REPORT CORRECTED 3-8-85  
CITY PLANNING COMMISSION

- APPLICATION:
- A. Negative Declaration
  - B. Amendment of the 1984 Airport-Meadowview Community Plan from Residential (4-8 du/na) to Residential (7-15 du/na).
  - C. Rezone from R-1 to R-1A (Sec. 13-4)
  - D. Tentative Map (Subdivision Ord.)
  - E. Special Permit for development in the R-1A zone (Sec. 7-C)

APPLC. NO. P85-007

# FRANKLIN MEADOWS

TYPICAL LOT LAY OUT ALONG MEADOWVIEW ROAD  
SCALE 1/16"=1'-0"

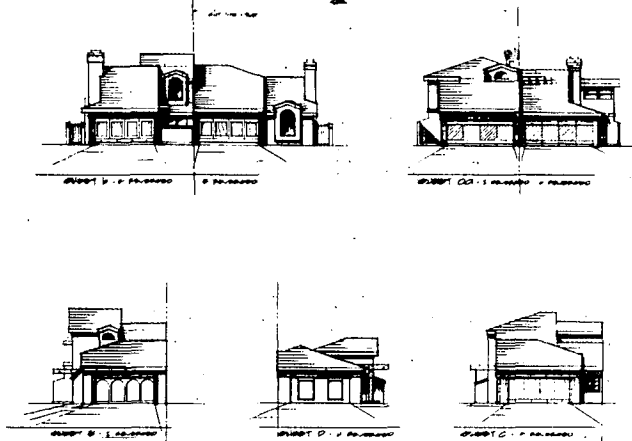
5. The applicant is also proposing to develop interior halfplex lots fronting on Meadowview Road. These units will be developed with circular drives to eliminate the need for backout access onto Meadowview Road. This will be accomplished by shared use of the driveway through cross access easements for the halfplex units. Appropriate language should also be incorporated into the Conditions, Covenants and Restrictions (CC & R's) of the homeowners' association prohibiting blockage of the circular drives.

- 8. Dedicate 'A' Street to a 50 foot right-of-way;
- 9. A copy of the Conditions, Covenants and Restrictions (CC & R's) shall be submitted to the Planning Director and City Attorney prior to final map approval. The cc & r's shall provide appropriate language restricting the blockage of the circular driveways fronting on Meadowview Road. Adequate

4. A copy of the Covenants, Conditions and Restrictions (CC & R's) shall be submitted to the Planning Director and City Attorney prior to final map approval. The CC & R's shall provide appropriate language restricting the blockage of the circular driveways fronting on Meadowview Road. Adequate provisions shall also be provided for the maintenance of the front yards throughout the project.

TYPICAL STREET ELEVATIONS  
SCALE 1/16"=1'-0"

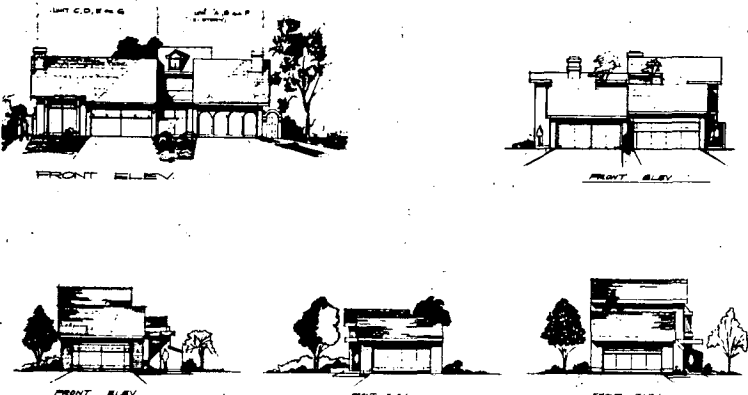
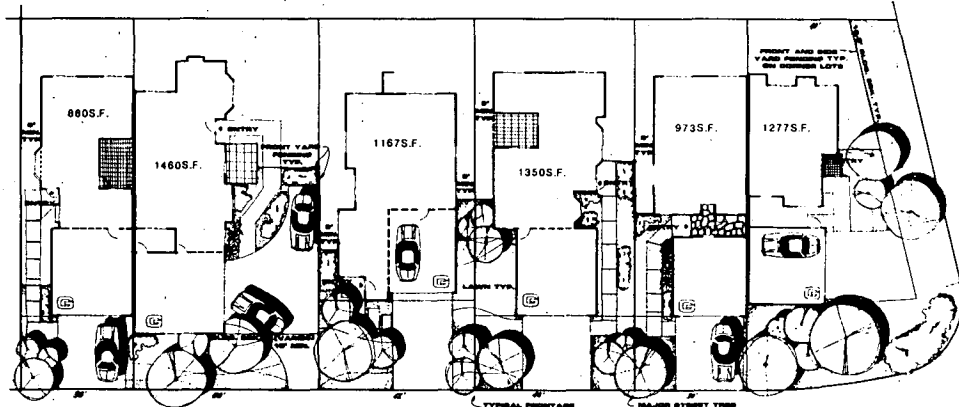
2. The proposed elevations indicate a dominance of the garage as the major feature of the unit fronting on the public streets throughout the development. Living areas with visual orientation along street frontages are minimal in some units and non-existent in other units within the proposed development. This design is inconsistent with goals for the community as they relate to reducing deteriorating influences and crime.

- a. The units shall be redesigned to eliminate the dominance of the garage on the front elevations. The revised design shall provide adequate living area with visual access along the street;
